PRODUCT CHANGE NOTIFICATION (PCN)

AMJE0909-0500-WHB-24
MODULAR CABLE

CHANGE NOTIFICATION: PCN 20220509_AMJE0909-0500-WHB-24

DESCRIPTION OF CHANGES:
CHANGE OF DATA SHEET
CHANGE OF DATA SHEET
New Draw.-No. ASS_7945_CArev02

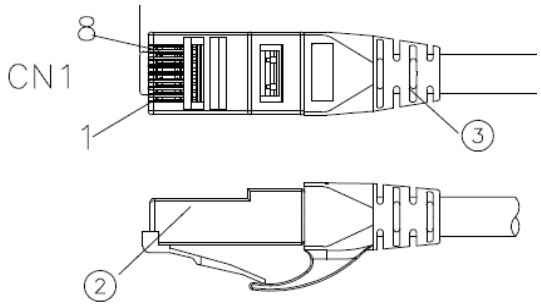
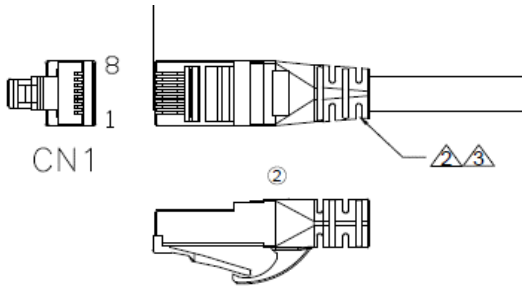
③	Molding	PVC 45P Color: see order code	NA	KG
②	CONNECTOR	RJ45 8P8C two fork Short type 3u" gold plated	2	PCS
①	CABLE	CAT6 UTP (24AWG*1PR)*4+PVC OD=5.8±0.3MM Color: see order code	NA	MM
NO:	NAME	DESCRIPTION	Q'TY	UNIT

3	Molding	PVC 65P Color: see order code ②	NA	KG
2	CONNECTOR	RJ45 8P8C PLUG 3u" gold plated ②	2	PCS
1	CABLE	CAT6 U/UTP (24AWG*1PR)*4+Cross+PVC Jacket OD=5.8± 0.3MM Color: see order code ②	NA	MM
NO:	NAME	DESCRIPTION	Q'TY	UNIT

Drawing-No.
ASS 7945 CA

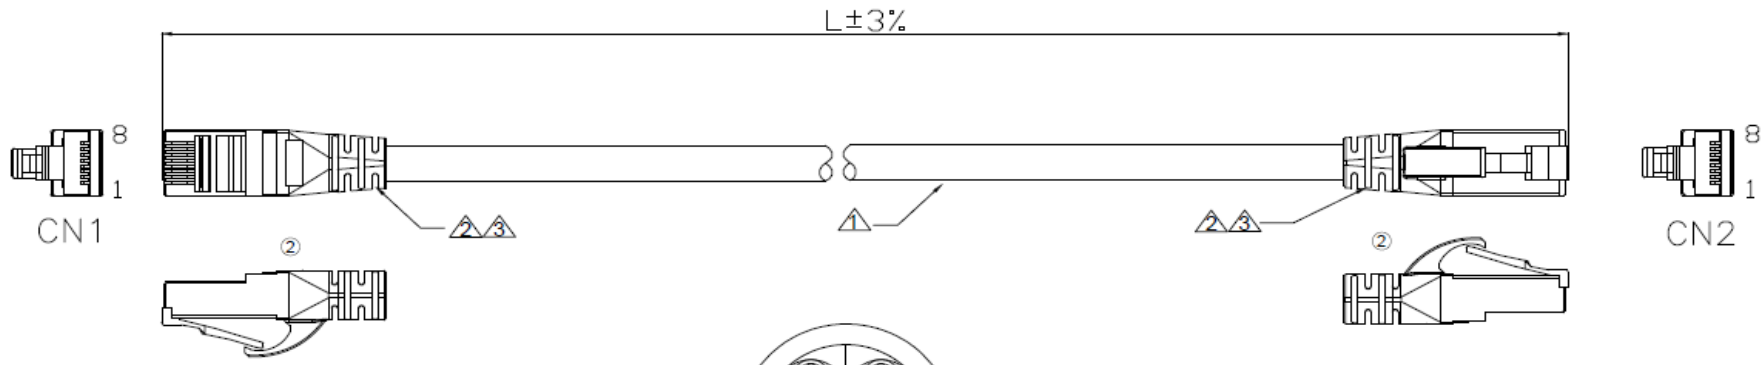
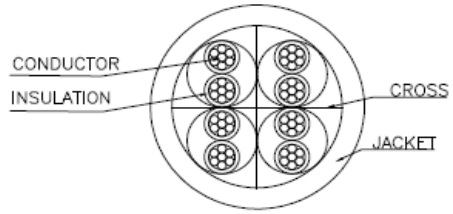
Id.	Modification	Date	Name
②	Change the plant	09.05.2022	Luca
①	Update the WSW order code	02.06.2017	Amy
⓪	Drawn	30.03.2017	Amy

NO:	NAME	DESCRIPTION	Q'TY	UNIT
3	Molding	PVC 65P Color: see order code ②	NA	KG
2	CONNECTOR	RJ45 8P8C PLUG 3u" gold plated ②	2	PCS
1	CABLE	CAT6 U/UTP (24AWG*1PR)*4+Cross+PVC Jacket OD=5.8± 0.3MM Color: see order code ②	NA	MM
